Amendments to the Drawings:

Application No. 10/674,739
Reply to Office Action dated 9/30/05
Annotated Sheet Showing Changes

Fig. 1A

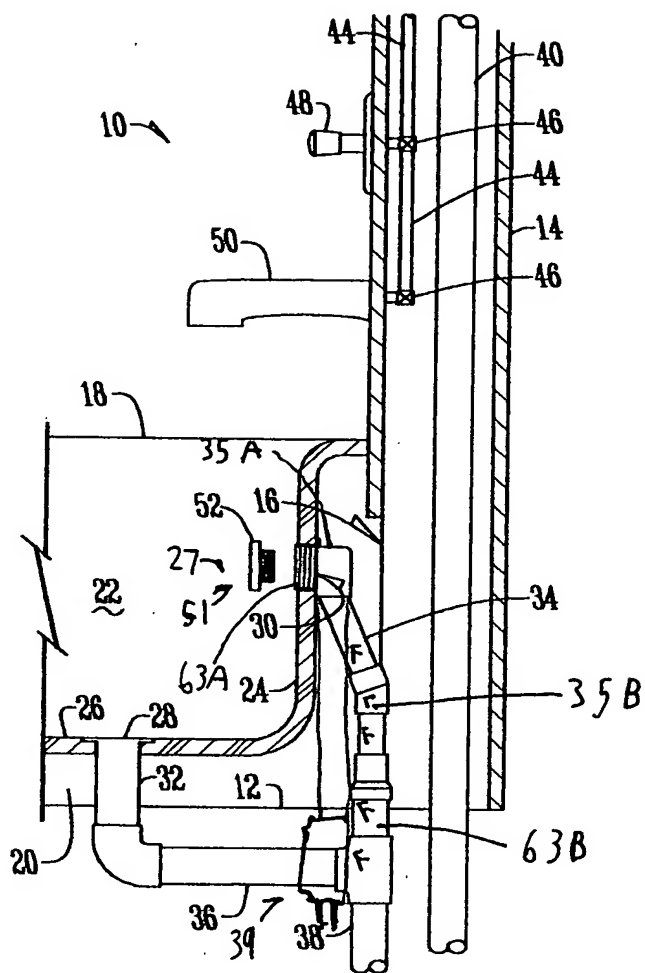
The attached sheets of drawings include changes to Page 1 of 2 and Page 2 of 2 with changes to Fig. 1A and Fig. 3. In Fig. 1A the drain pipe 34 is drawn as L-shaped consistent with Fig. 3 and numerals have been added. In Fig. 3 numerals have been added.

The Examiner has objected to the drawings under 37 C.F.R. § 1.83(a). Specifically the Examiner raises four issues. First, the Examiner asserts that the drawings do not show a drain pipe having an inverted L-shape as called for by claim 1. Fig. 1A has been amended to provide a drain pipe of one piece construction that has an L-shape. This L-shaped drain pipe is shown in Fig. 3 and thus the drawing change has proper antecedent basis in the original disclosure. Thus, this drawing rejection is considered overcome.

downwardly for connection to a fluid drain system. As discussed above, Fig. 1A has been amended to make the overflow drain pipe an L-shape such that it has a horizontal portion 35A and a vertical portion 35B that extends to a fluid drain system 39. Additionally, the L-shaped description of the drain pipe along with the description of the horizontal leg and the vertical leg extending to the fluid system has been added in an amendment to the specification. This amendment to the drawing, Fig. 1A and to the specification gains antecedent basis in the original claims and in Fig. 3. Again, specifically Fig. 3 shows the overflow drain pipe 34 that has an L-shape with a horizontal portion 35A and a vertical portion 35B. As seen in Fig. 3, the pipe includes the threaded end portion that is part of the horizontal leg. Thus, the amendments to the drawings and specification has proper antecedent basis within the originally filed application.

The Examiner has objected to the phrase "fluid drain system" as not shown in the drawings. The fluid drain system 39 comprises the horizontal pipe 36 and drain pipe 38. This description has been added to the specification and numeral 39 has been added to Fig. 1A to show the same. As the horizontal pipe 36 and the drain pipe 38 are both presented in original Fig. 1A, this amendment to the drawings and specification has proper antecedent basis in the original specification.

30. Applicant has also amended the specification to add the overflow drain pipe 34 also has a second end in communication with a fluid drain system 39. As seen this amendment gains antecedent basis from the claims and from Fig. 1A that has been amended to provide Figures 63A and 63B showing these elements that are properly within the original drawings. Thus no new matter has been entered and all the drawings objections are considered overcome.

The specification has been objected to for failing to provide proper antecedent basis for several claim terminologies. The first claim terminology is "an overflow system for a bathtub". The Applicant has added this limitation to page 3, line 23 of the specification and has added numeral 27 to Fig. 1A that shows the overflow system. This amendment gains antecedent basis from the original application and specifically from Fig. 1A that shows the overflow system.

The next claim limitation the Examiner objects to is "a plumbing test system". The specification at page 4, line 5 has been amended to state that with reference to Figs. 2 and 3, both Figures show parts to a plumbing test system 51. Numeral 51 has been added to Fig. 1A and thus the plumbing test system was provided in the original specification and this amendment has proper antecedent basis. Thus this objection is considered overcome.

Fig 3

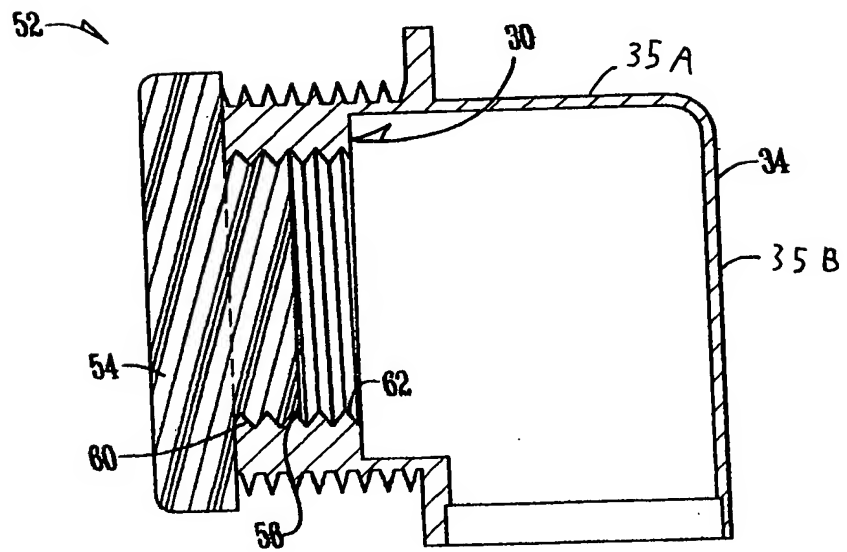
The next objection to the specification is that it does not provide a drain pipe having an inverted L-shape. Page 3, line 28 has been amended to state that overflow drain pipe has an inverted L-shape. This amendment gains its antecedent basis from the original claims of the parent application, Serial No. 10/247,247 and the original claims in this application. Additionally this limitation gains antecedent basis from Fig. 3 that shows a overflow drain pipe 34 that has an inverted L-shape.

The next limitation of the specification is objected to is "a solid cap threaded into interior threads of the horizontal leg extending through the overflow port to close the end of the horizontal leg". This exact limitation has been added to the specification at page 4, line 11 and as discussed above regarding the amendments to the drawings, has proper antecedent basis within Figs. 1A and 3 of the original application and also within original claims 1 and 2. Specifically Fig. 3 shows this closed arrangement.
